Addendum #	1	Date Issued	4-19-2024
Project Name Job #	DSU Woods Hall Improvements - Phase 2		20233600
Bid Date Time	April 24, 2024		2 pm MDT

THIS ADDENDUM AMENDS AND BECOMES PART OF THE CONTRACT DOCUMENTS FOR EAPC PROJECT 20233600 DATED 1-16-2024. EACH BIDDER SHALL ACKNOWLEDGE RECEIPT OF THIS ADDENDUM BY MARKING THE ADDENDUM NUMBER AND DATE ON THE BID FORM.

A1.8

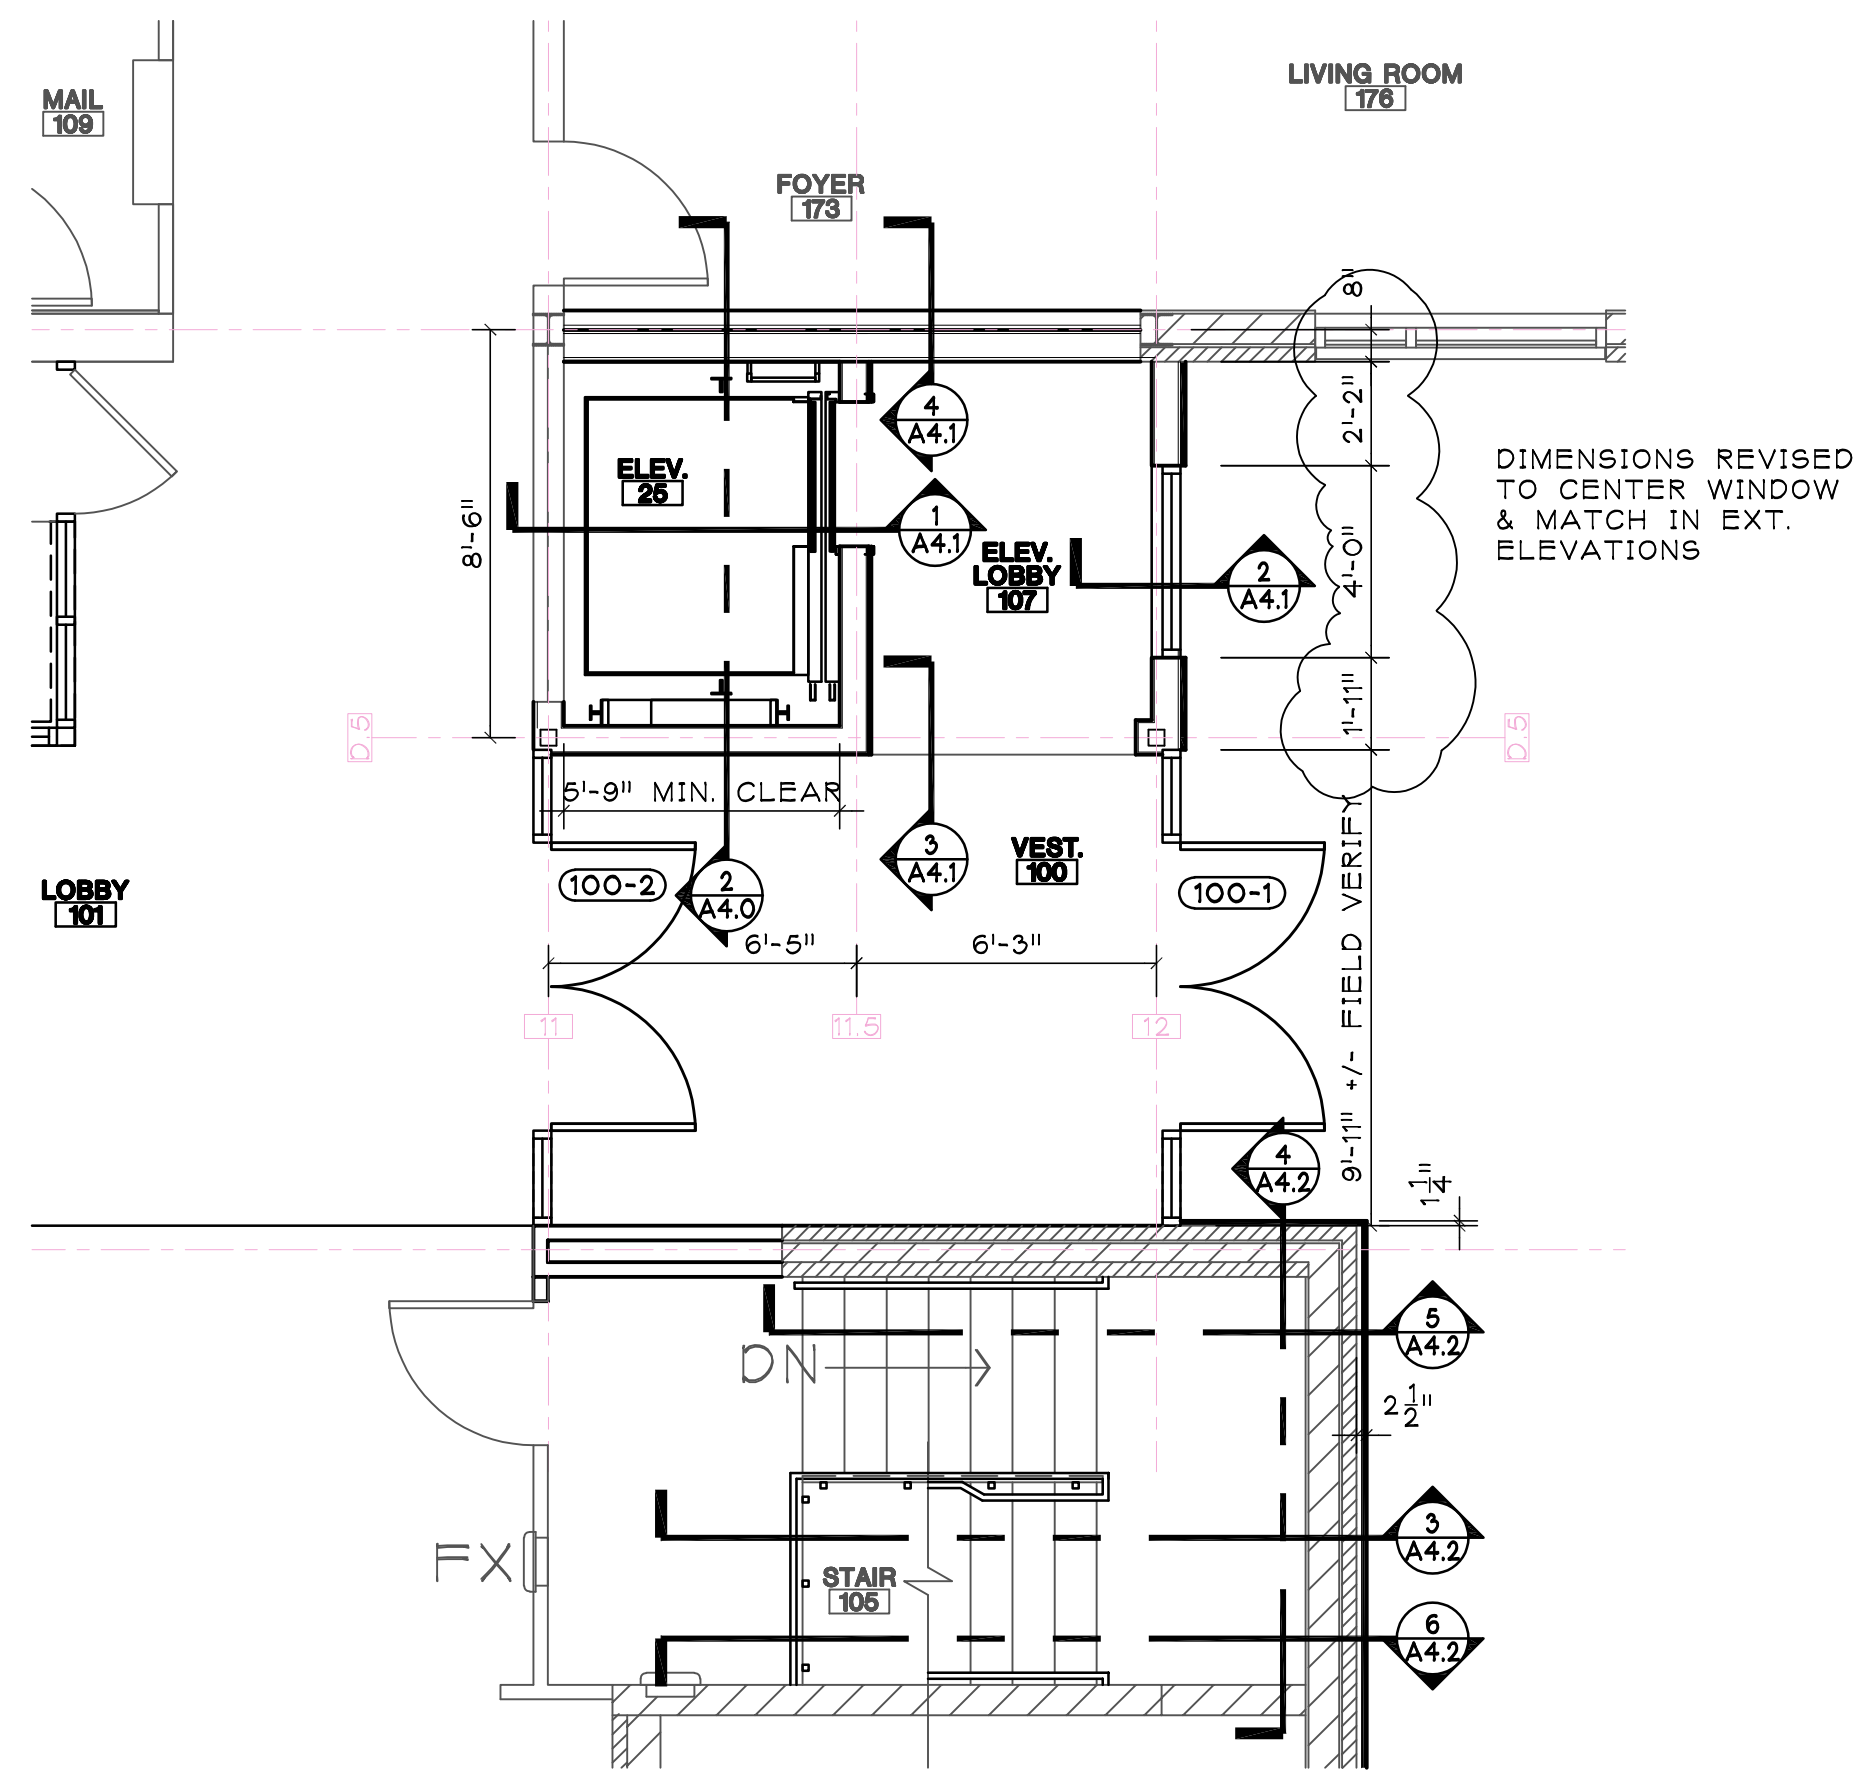
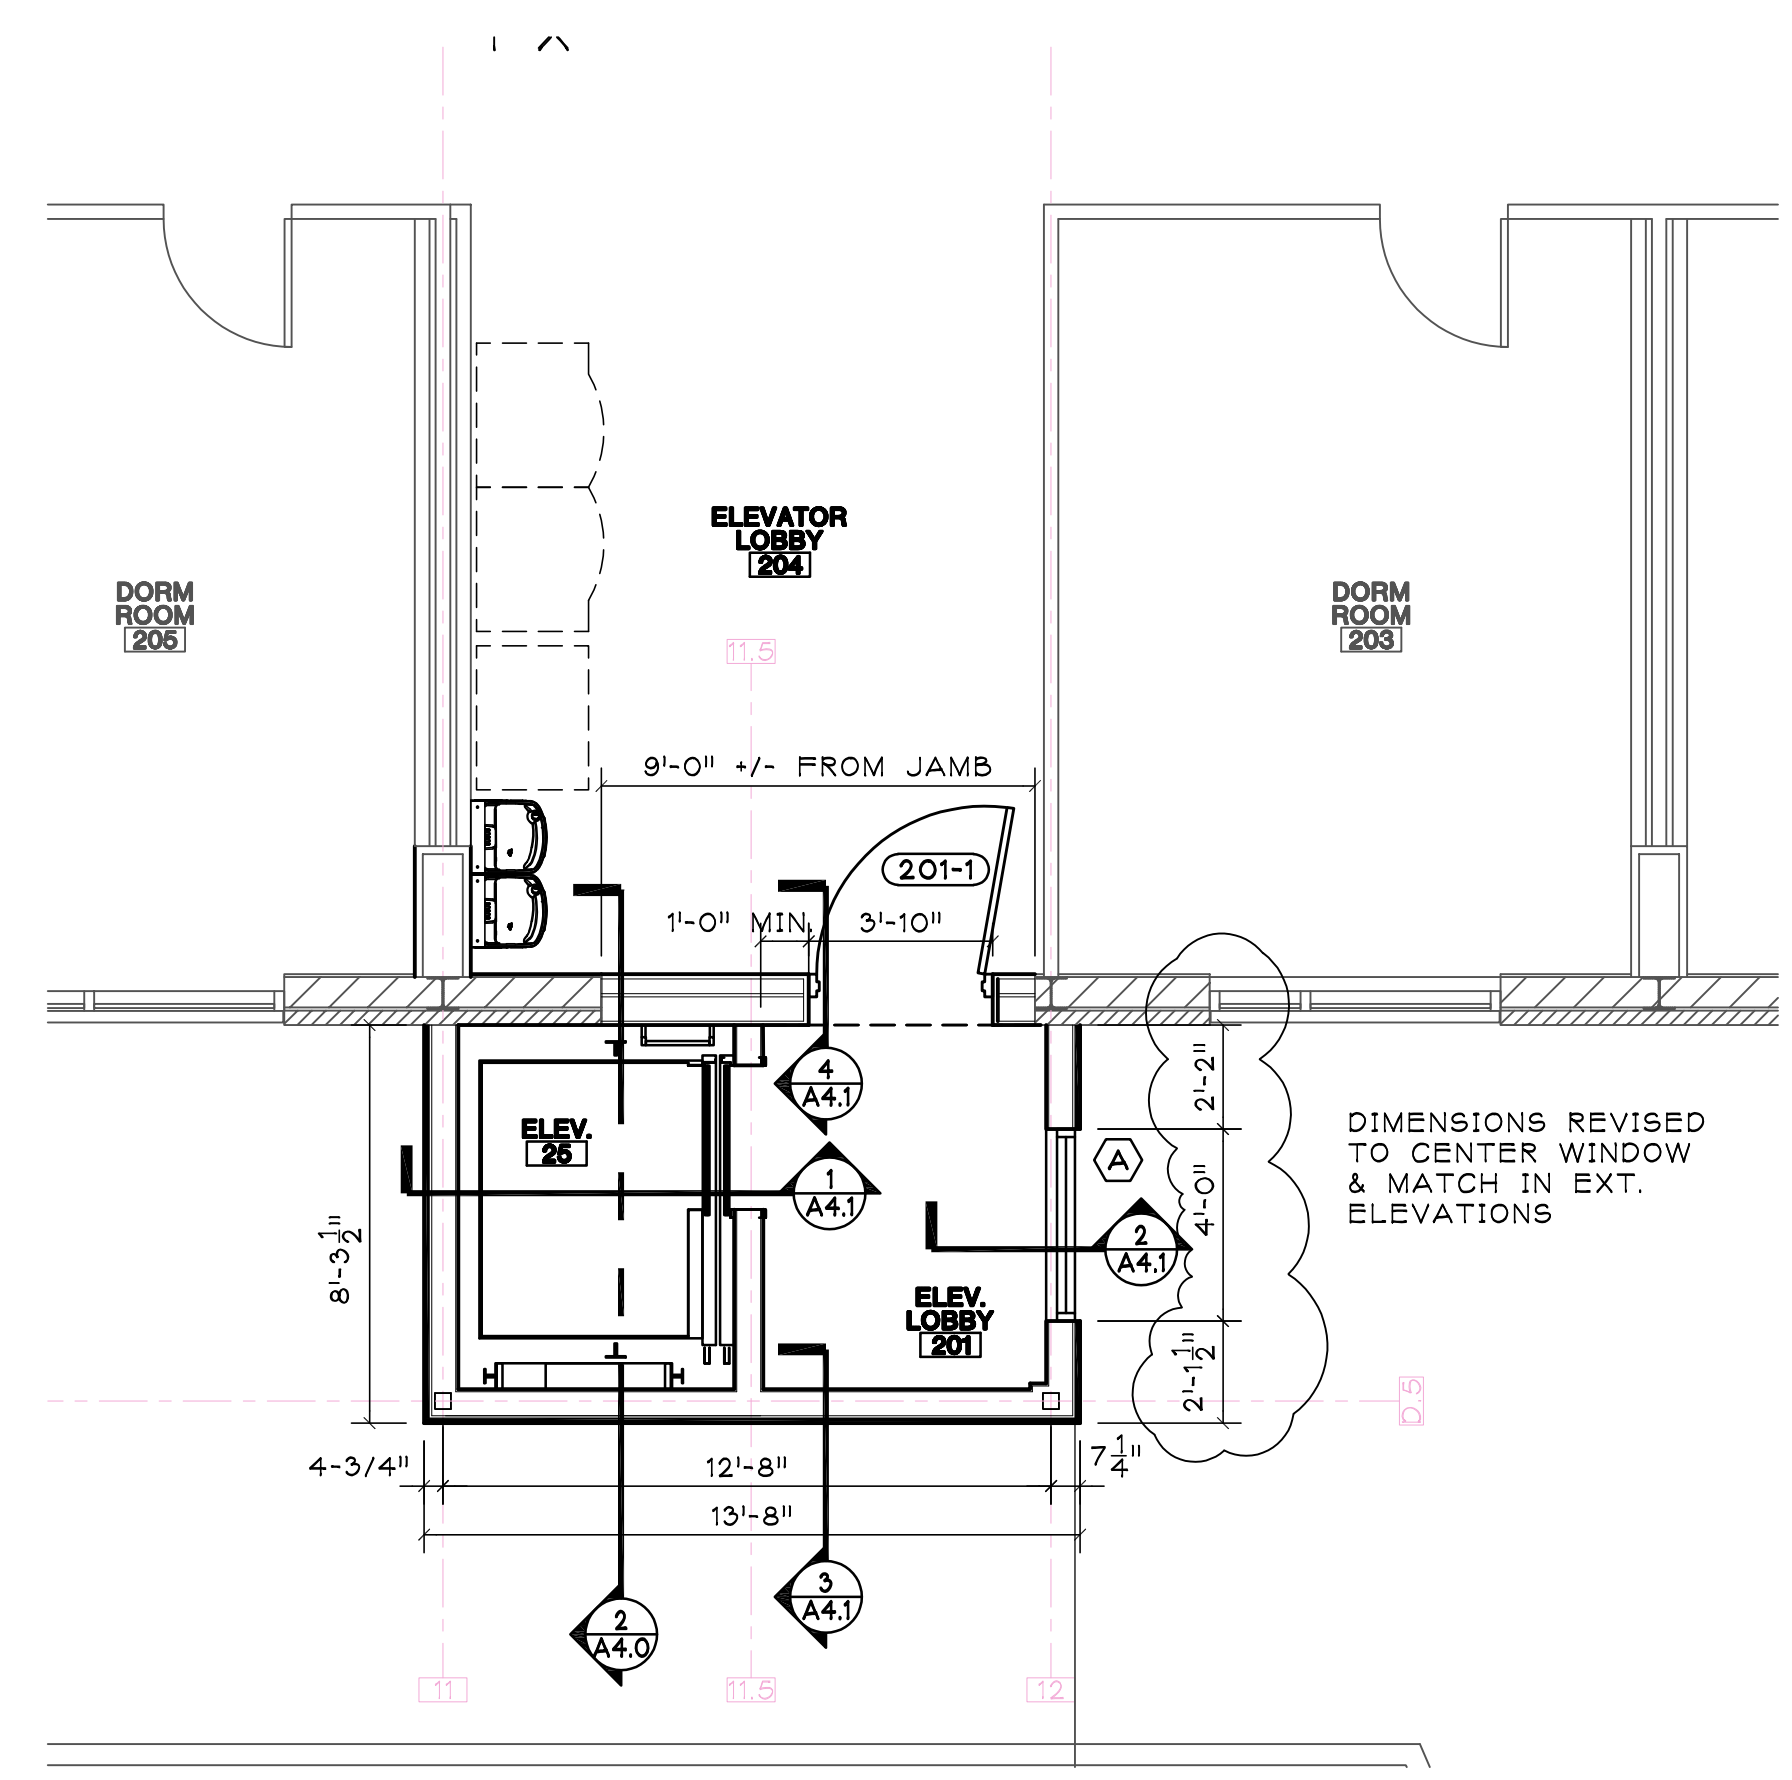
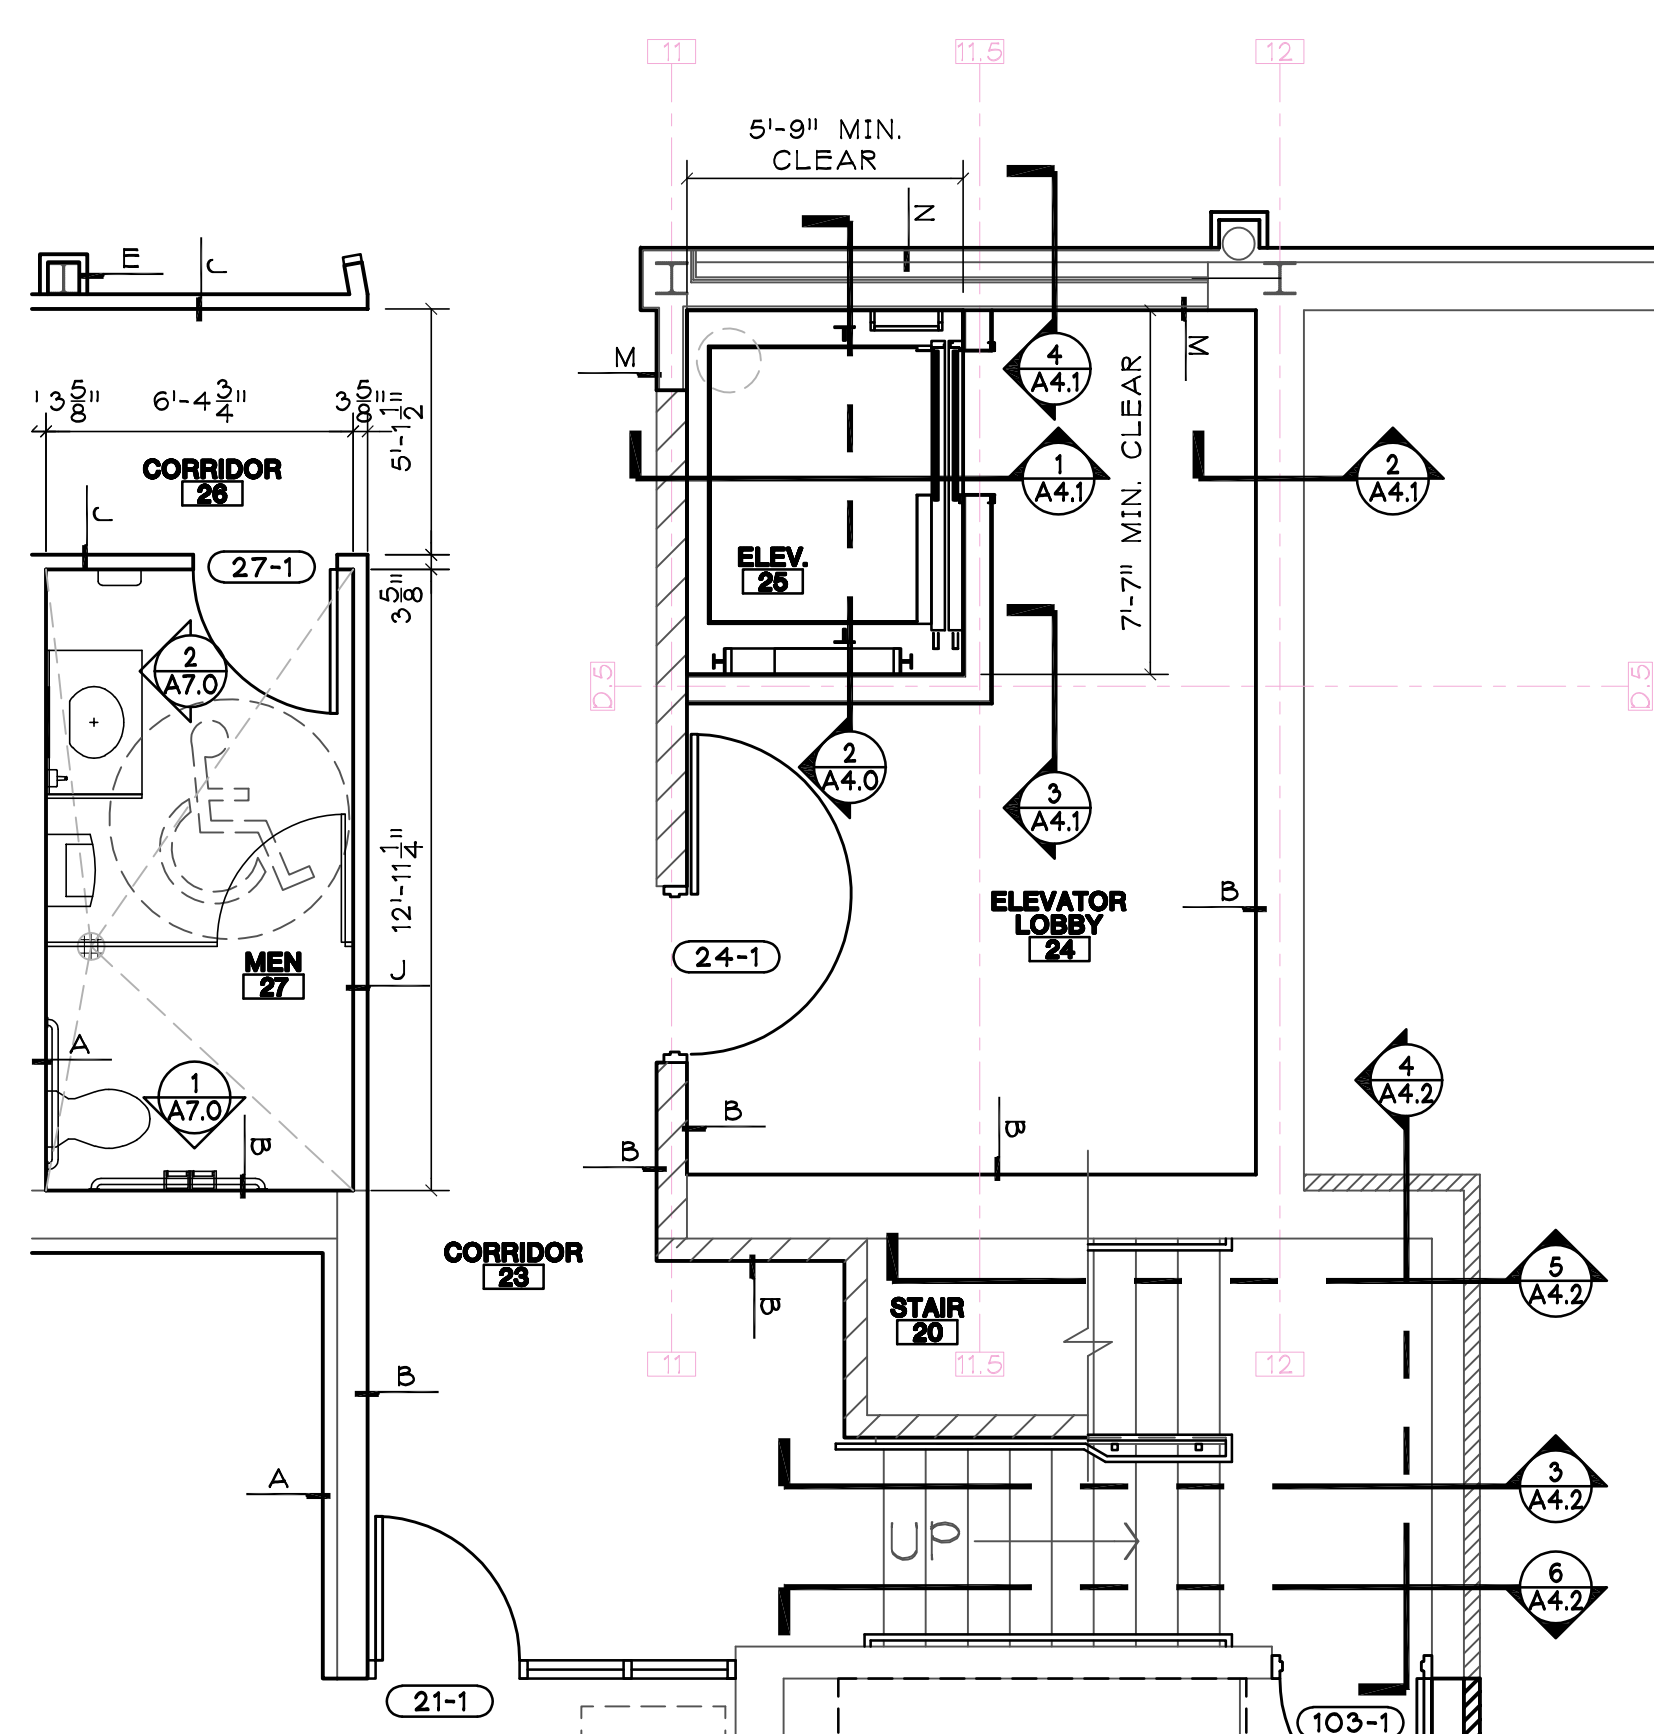
ITEM #6: SHEET 1.8 - Elevator Floor Plans: Replace Sheet with Attached Revised Sheet A1.8. Revised Window & Wall Dimensions as highlighted.
